# ADDENDUM

**Project:** City of Lawrence  
Veteran's Memorial Stadium  
**Date:** October 21, 2016

**Cc:** Lance Hamel – Lawrence DPW  
Rita Brousseau - Purchasing Dept.  
**Issue No.** 1

## 1.0 Plan Set - Sheet L2 of 2 - Detail #3 (Football Field Layout)

Image #1

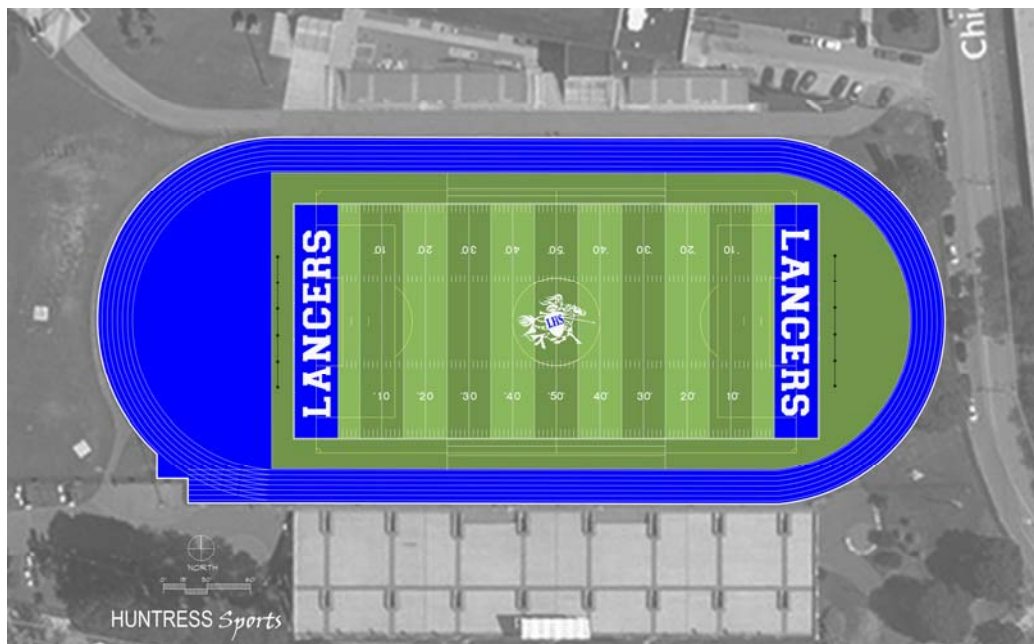
- a. The synthetic turf carpet/fibers in both football end zones to be tufted NAVY BLUE with inlaid WHITE letters spelling LANCERS. See Image #1 for detail. All other requirements for either tufted, inlaid or painted sports lines, letters and logos are to be installed as per the original specifications.

1. Is the alternating panel color every 5 yards or 10 yards?

2. Does the alternating panel color extend beyond the football field sideline?

*Answer: Alternating panel color is every ten yards, as shown in Image #1.*

*A. No, the alternating panel color stops at the limit of the football side line, as shown in Image #1.*
